SERVICE INSTRUCTION

RUNNING MODIFICATIONS ON ROTAx_® 2-STROKE UL AIRCRAFT ENGINES SI-2ST-004 R1

Running modifications on ROTAx_® 2-stroke UL aircraft engines.

View: **Rotary valve drive 582 UL**
Fig.: 1and 2

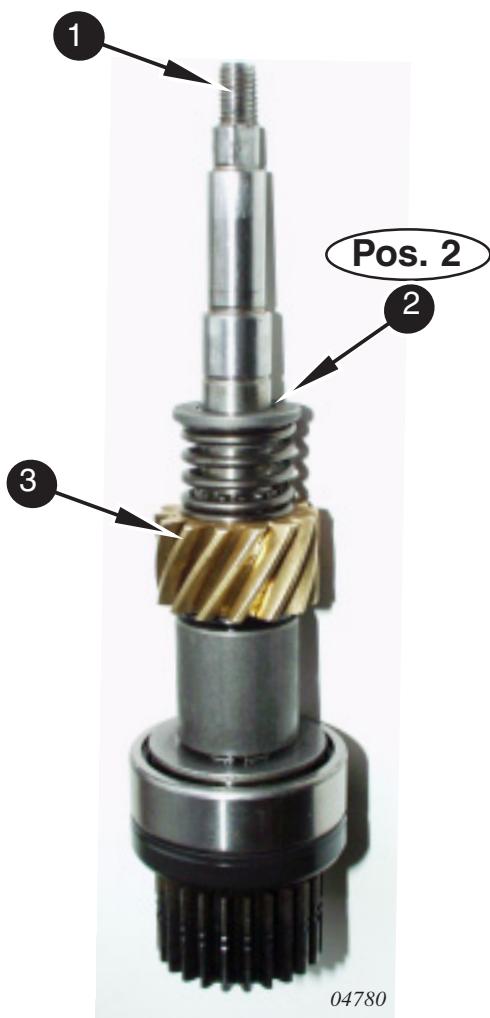
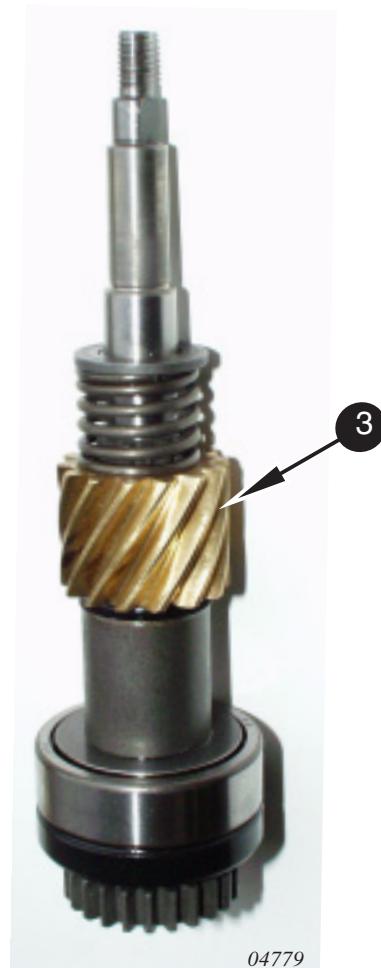
By reason of standardization a new rotary valve shaft unit has been introduced on the 582 UL mod. 99.

The new rotary valve shaft (1) part no. 837 243 has two grooves for fixing the rotary valve shaft components.

■ CAUTION: At assembly of the rotary valve shaft components make sure to fit circlip (2) part no. 845 160 in the second groove of the rotary valve shaft (thus reaching a higher pretension on the rotary valve (3)). In the first groove, utilized on other engine types, no circlip shall be fitted!

Bild / Fig. 3

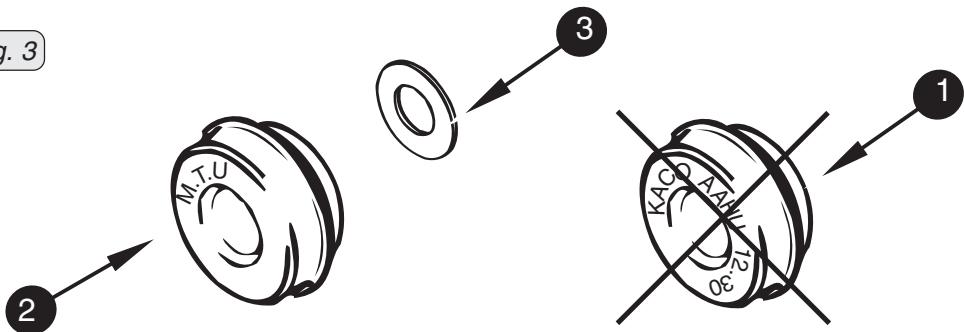
Owing to further development and standardization of parts the rotary valve seal (1) part no. 850 940 has been replaced by the rotary valve seal (2) part no. 850 942 along with an additional shim (3) part no. 944 382.

■ CAUTION: Because of the shorter design the new rotary valve seal (2) has to be fitted along with the shim (3).

Bild / Fig. 4

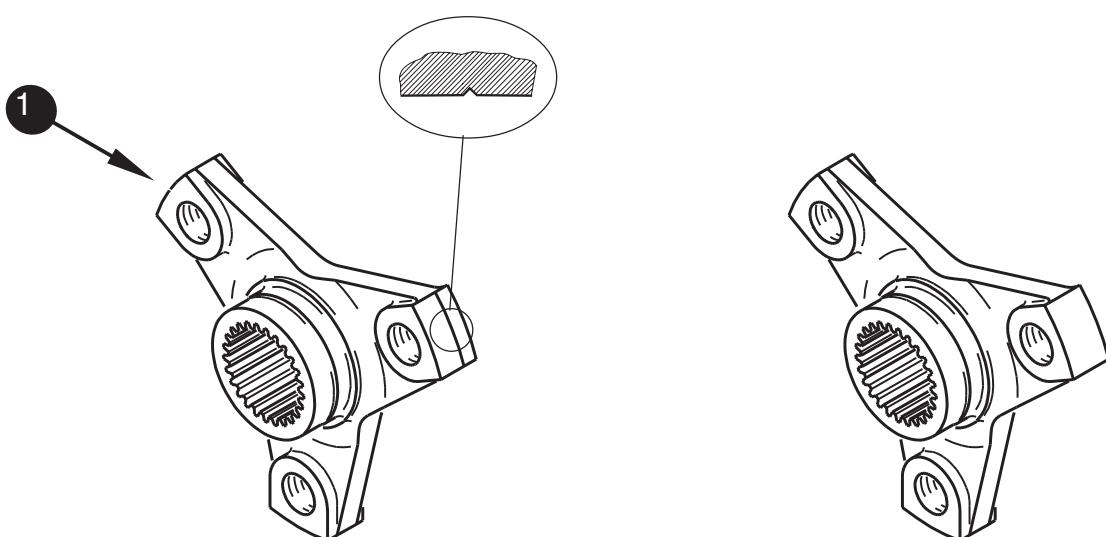
Owing to continuous refinement of the gearbox sealing a new combination of coupling flange (1) part no. 958 971 and oil seal (2) part no. 950 084 has been introduced.

■ CAUTION: A combination of components of old and new design must not be fitted i.e. the new type of coupling flange (1) with identification groove may only be fitted together with the new oil seal (2) part no. 950 084.

◆ NOTE: Commencing with production code O6 new sealing components has been introduced in serial production. The gasket set for the reduction gearbox type „C“ and „E“ contains the new oil seal (2) part no. 950 084, only.

Bild / Fig 5

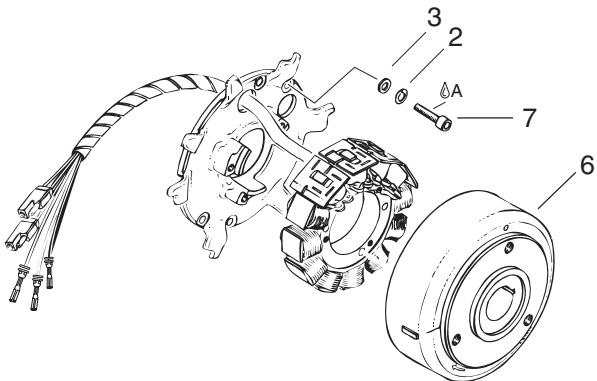
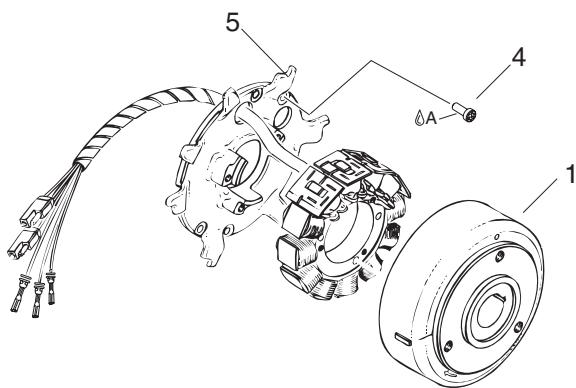
Owing to further development and standardization of parts a new fly wheel part no. 996822 (1) has been introduced.

- Omit the installation of washer (2) and lock washer (3) with the introduction of a new magneto flywheel with covered magnets and thus higher installation dimension of approx. 3mm (0.12 inch).
- Use of a new torx screw M5x16 (4) for stator plate (5) installation.

■ CAUTION: For the new magneto flywheel configuration part no. 996822 (1) the new torx screw (4) has to be used (tightening torque 6 Nm (55 in.lb.)). For the old design of the magneto flywheel (6) the allen screw (7) as well as the new torx screw (4) can be used for installation of the stator plate.

◆ NOTE: Due to the TUFLOK-coating of the torx screw it is necessary to remove the residues of the coating at disassembly and reuse. Use LOCTITE 221 in this case. Alternatively a new part can be installed.
